## TEXAS COMMISSION ON ENVIRONMENTAL QUALITY

NAME OF PROJECT: **Uecker Tract Unit 1**; Located 650 feet southeast of the Wiley Road and FM 1863 intersection; City of Bulverde, Texas

TYPE OF PLAN: Request for Approval of a **Water Pollution Abatement Plan (WPAP)**; 30 Texas Administrative Code (TAC) Chapter 213 Edwards Aquifer

Re: **Uecker Tract Unit 1 WPAP**  
Regulated Entity No. RN108931015; Additional ID No. 13000049  
Response to Notice of Deficiency (NOD1)

EXHIBIT 1

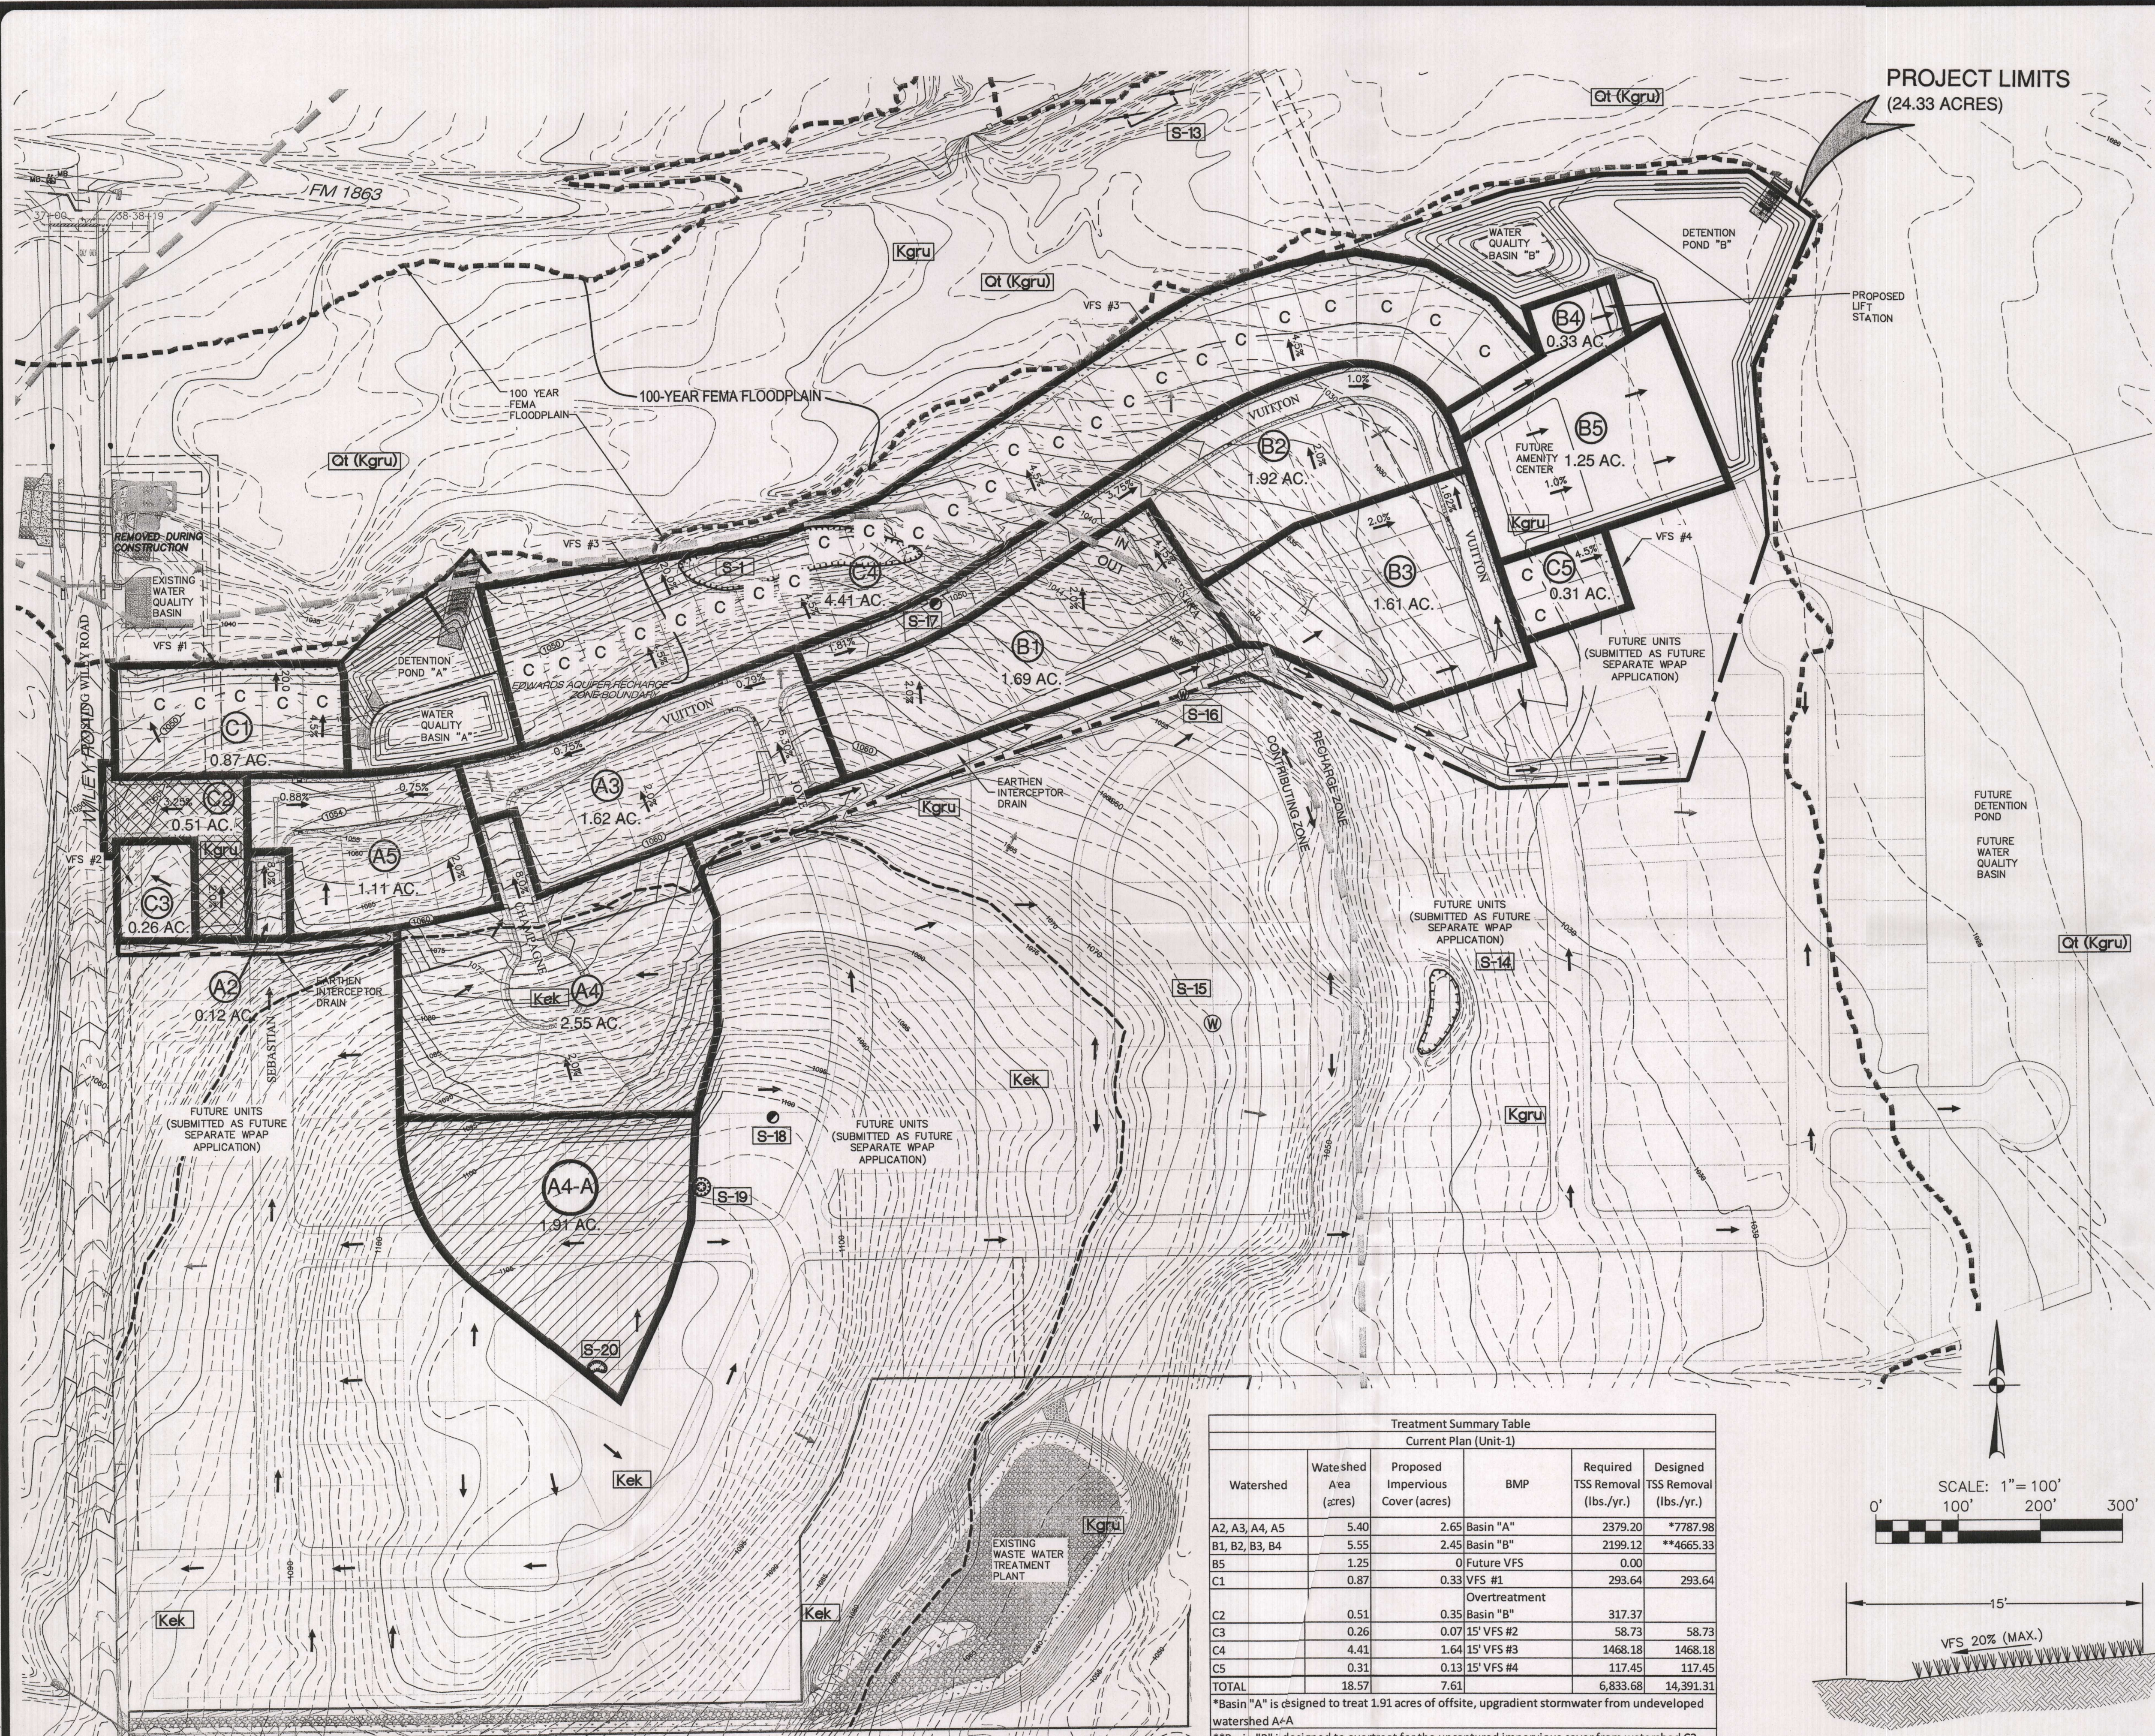
1. On the Site Plan, please show sensitive features.

2. On the Site Plan, two VFS #4 are shown in different locations. Please verify which VFS is #4.

***Response: Please find attached revised exhibits.***

***Response: Please find attached revised exhibits.***

NO.	REVISION	DATE
1	VFS #3 LABEL PER TCEQ	2-18-2016
2	ADDED GA FEATURES PER TCEQ	2-18-2016

#### TYPICAL LOT DRAINAGE DETAIL FOR FHA TYPE C LOTS

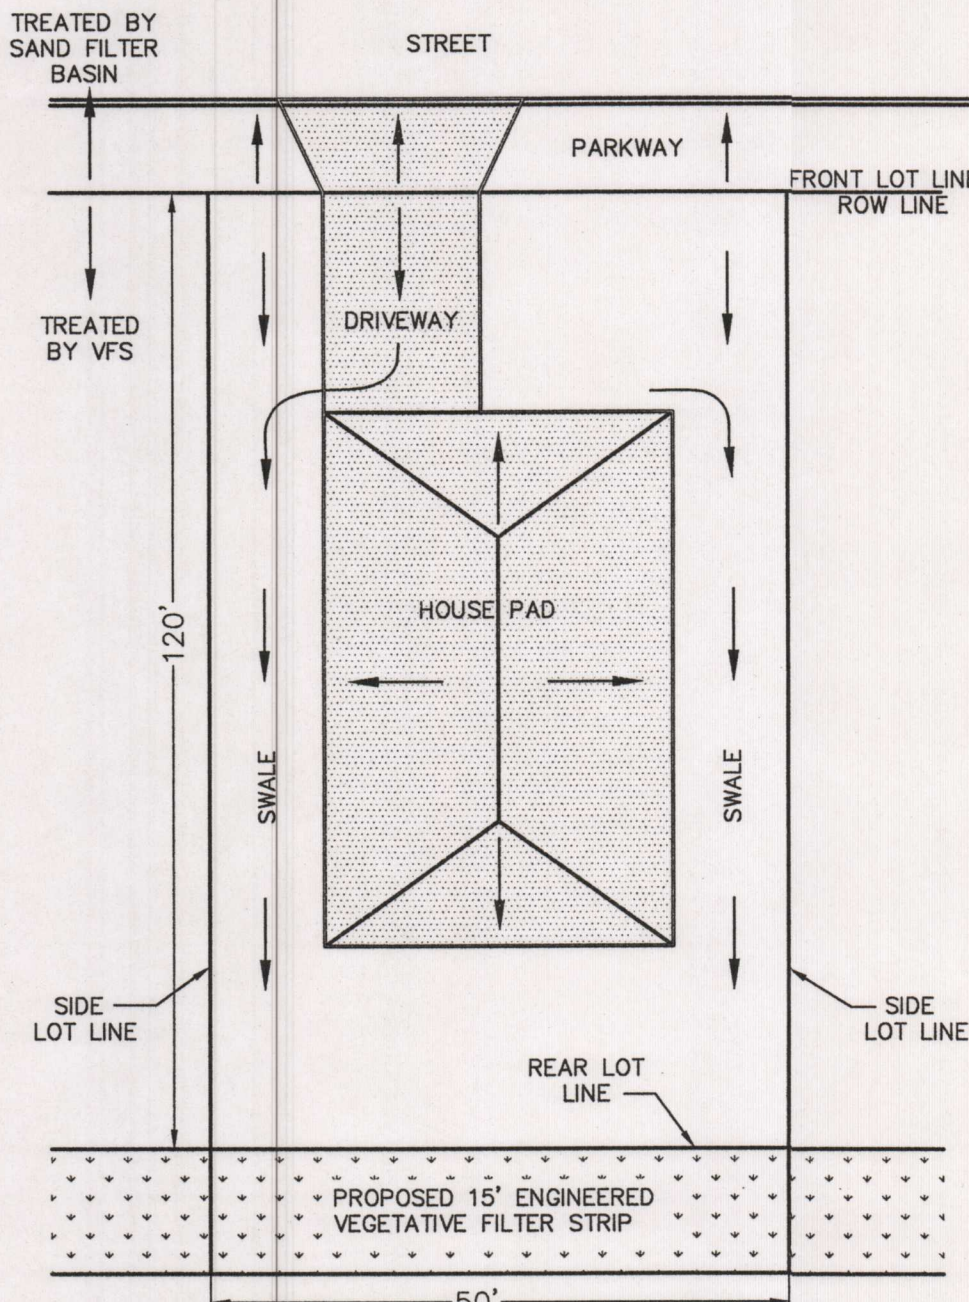
3. On the Permanent Pollution Abatement Plan, in the "Typical Lot Drainage Detail for FHA Type C-Lots", please show that no more than 75 ft drains to the Vegetative Filter Strip.

***Response: Per previous discussions with TCEQ and additional note on Exhibit 3 "Typical Lot Drainage Detail" as well as drainage illustration, no more than 72' of impervious cover will drain to the 15' engineered VFS due to roof drainage.***

NOTE: ROOF DRAINAGE PATTERN IS APPROXIMATE AND SUBJECT TO CHANGE BASED ON FINAL HOUSE PAD DESIGN. HOWEVER RUNOFF FROM DRIVEWAY, ROOF OR OTHER IMPERVIOUS SURFACES WITHIN THE LOT WILL NOT FLOW ACROSS MORE THAN 72' OF IMPERVIOUS SURFACE BEFORE REACHING THE PROPOSED 15' ENGINEERED VEGETATIVE FILTER STRIP. FINAL LOT GRADING TO ALLOW FOR SHEET FLOW OVER VEGETATIVE FILTER STRIP.

#### GEOMEMBRANE LINER DETAIL

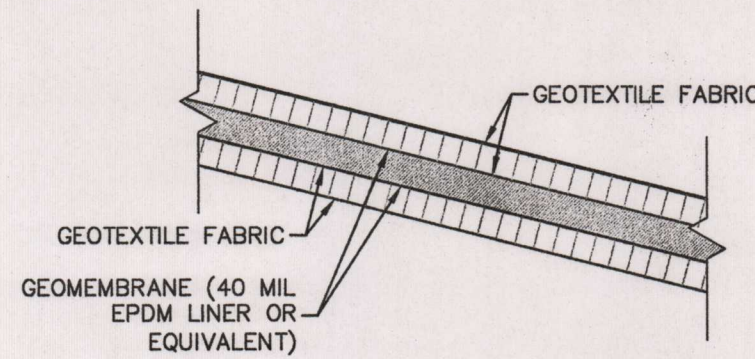
4. Please add Geomembrane properties that match the following specifications.

4. Please add Geomembrane properties that match the following specifications.

<sup>1</sup> Geomembrane min thickness: 30 mils, UV resistant, and			
<sup>2</sup> Geotextile Fabric (for protection of Geomembrane) (Page 3-39)			
Unit Weight	---	Oz/yd <sup>2</sup>	8
Filtration Rate	---	In/sec	0.08
Puncture Strength	ASTM	Lb	125
Mullen Burst Strength	ASTM	Psi	400
Tensile Strength	ASTM	Lb	200
Equiv. Opening Size.	US Stand. Sieve	No.	80

***Response: Please find attached revised exhibits.***
